# Access Compliance Report

## Public Rights-of-Way

### (Curb Ramps)

Intersection ID: 12937	Main Street: E_W_T_HARRIS_BV	Cross Street: HICKORY_GROVE_RD	Location: NW
ADA ID: F1F23EA58B5E	Ramp Type: Perp	Initial Pass/Fail: Fail	Overall Compliance: No
		Severity Score: 25

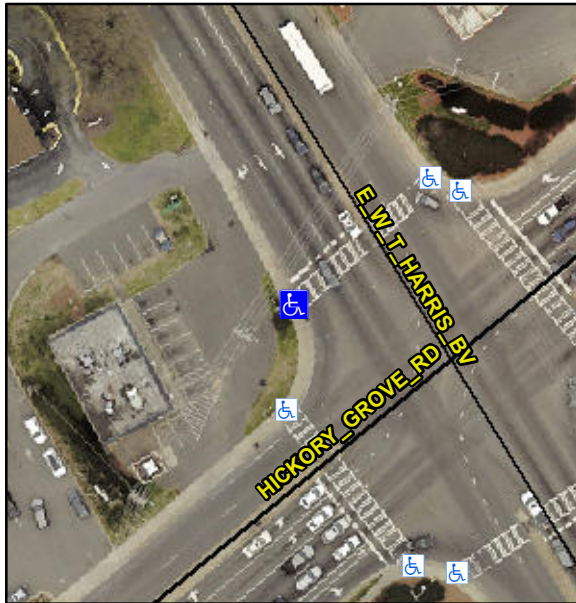
**Not Found, R304.2.2**

Compliance	Description	Data	Compliance	Description	Data
N/A	Ramp Length (in)	24.5	No	Ramp Slope (%)	15.3
Yes	Ramp Width (in)	48.0	Yes	Ramp XSlope (%)	0.1
N/A	Flare Type LT	N/A	N/A	Flare Type RT	N/A
N/A	Flare Slope LT (%)	N/A	N/A	Flare Slope RT (%)	N/A
N/A	Flare Traversable LT?	N/A	N/A	Flare Traversable RT?	N/A
N/A	Landing Length (in)	N/A	N/A	DWS Provided?	N/A
N/A	Landing Width (in)	N/A	N/A	DWS Contrast?	N/A
N/A	Landing Slope (%)	N/A	N/A	DWS Length (in)	N/A
N/A	Landing X Slope (%)	N/A	N/A	DWS Full Width?	N/A
N/A	Landing Curb? (Y/N)	N/A	N/A	DWS Offset (in)	N/A
N/A	Shared Landing?	N/A			
N/A	Gutter Ponding?	N/A	N/A	Gutter Slope (%)	N/A
N/A	Gutter Lip Ht (in)	N/A	N/A	Gutter X Slope (%)	N/A
N/A	Painted X Walk1?	Yes	N/A	Painted X Walk2?	N/A
	X Walk 1 Direction	To S		X Walk 2 Direction	N/A
N/A	X Walk 1 Width (in)	117.0	N/A	X Walk 2 Width (in)	N/A
	X Walk 1 Slope (%)	2.3		X Walk 2 Slope (%)	N/A
	X Walk 1 X Slope (%)	0.3		X Walk 2 X Slope (%)	N/A

**Remove & Replace Entire Ramp.**
